SERVICE BULLETIN

SUBJECT: ADDITIONAL CLEARANCE FOR ENGINE EXHAUST STACKS

Plan View of Rework to Nacelle LH Lower Sill (RH Lower Sill Similar) Figure 1

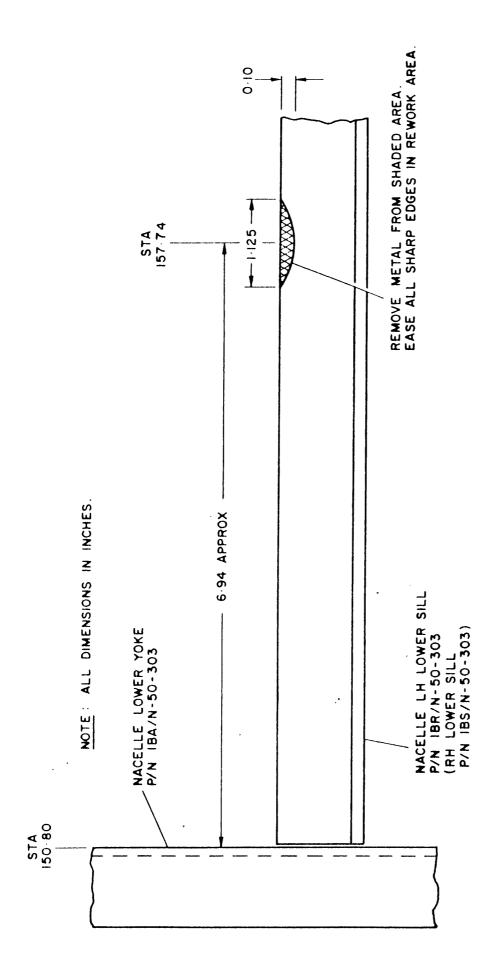
Contact may occur between engine exhaust stack weld flanges and the lower sills of the nacelle side plates resulting in damage to the horizontal flange of the sills.

Additional clearance is gained by relieving the lower sills in the area where contact may occur between the exhaust stacks and the lower sills. The approximate location of damage is 7.75 inches aft of the rear face of the nacelle lower yoke.

- A. Open the LH and RH nacelle lower cowl (Refer M.M. 71-10-00).
- B. Inspect the lower sills of each nacelle. If the lower sills have been relieved as shown in Figure 1, no more action is required and the lower cowls may be closed.
- C. If the lower sills have not been relieved, rework the horizontal flange of the lower sills as shown in Figure 1, easing all sharp angles.
- D. Repair the surface finish of the reworked areas (Ref SRM 51-30-00).
- E. Close the LH and RH nacelles lower cowls (Ref MM 71-10-00).
